Office Action Summary	Application No. 10/541,297	Applicant(s) KRESS, JURGEN	
	Examiner ALIREZA NIA	Art Unit 3779

DETAILED ACTION

Inserted image 1: Fig. 6 from Silverstein 4,646,722

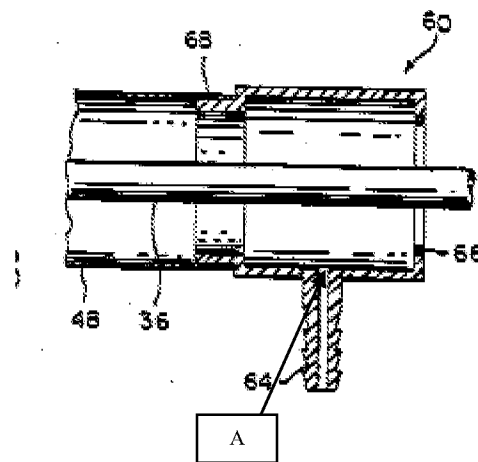
9. Regarding claims 29-30, 32-38, and 42, Silverstein discloses an endoscope 8 with hygiene protection 10,30, comprising a cover 10,30,48 closed at a distal end 32 and transmissible for optical information via 32,44,46, at least on a front face 32 of said cover 10,30,48, and capable of being rolled via 48 in an axial direction of said endoscope 8, wherein said cover 10,30,48 includes a material 48 that is airtight, watertight and impermeable to pathological microorganisms with connection of said cover 10,30,48 to said working channel 36,38 to said distal end 32 of said cover 10,30,48 being made airtight, watertight and impermeable to pathological microorganisms (col. 6, lines 35-46), a working channel 38,36 extending parallel to said endoscope 8 via 21 and terminating in an open mode via 38,40,42 at said distal end 32 of said cover 10,30, said working channel 36,38 being connected only to said distal end 32 of said cover 10,30,48 and positioned between an outer side 12 of said endoscope 8 via 21 and an inside of said cover 10,30,48 (col. 6, lines 16-46, 58-68, col. 7, lines 1-14, 41-54, figs. 1-3), and consisting of only a single vacuum channel 64 (figs. 5-6, col. 7, lines 60-65), having at least one opening A, and terminating at said inside of said cover 10,30,48 with said at least one opening A terminating inside of said cover 10,30,48 in a direction facing said endoscope 8 (the direction is facing endoscope 8 and portion 14 of endoscope 8), said single vacuum channel 64 being a dedicated channel 64 that is a different channel 64 from said working channel 36,38 (fig. 4). Silverstein further discloses means 48 (the elastomeric material) for varying cross-sectional diameter via 48,60,64 (col. 7, lines 47-60), wherein said cover 10,30,48 is flexible and elastic and foldable in the axial direction of said endoscope 12 via 48 (col. 6, lines 58-68), wherein at

least a portion of said cover 10,30,48 inherently has an internal diameter that is larger than an external diameter 12 of the endoscope 8. Silverstein further discloses a transparent pane or lens 32,44,46 on said distal end 32 of said cover 10,30,48 on said front face 32 of said cover 10,30 (col. 6, lines 47-57), wherein said transparent pane or said lens 32,44 at least partially forms said front of face 32 of said distal end 32 of said cover 10,30,48 via 46, wherein said distal end 32 of said cover is an optically transparent cap via 32,44, wherein said distal end 30,32 of said cover 10,30,48 has a wall thickness that is greater than wall thickness of a non-distal region 48 of said cover 10,30,48, wherein said cover 10,30,48, when open at a proximal end 48, is fixable to be airtight on a shaft 12,14 of said endoscope 8 via 48,66 (col. 6, lines 62-68). Silverstein further discloses means (suction, fig. 4) for applying sub-atmospheric pressure to said single vacuum channel 64 during use of said endoscope 8 (col. 6, lines 28-35). Silverstein further discloses depressions 21 in an axial direction on an outer surface of said endoscope 8 (col. 6, lines 16-21).
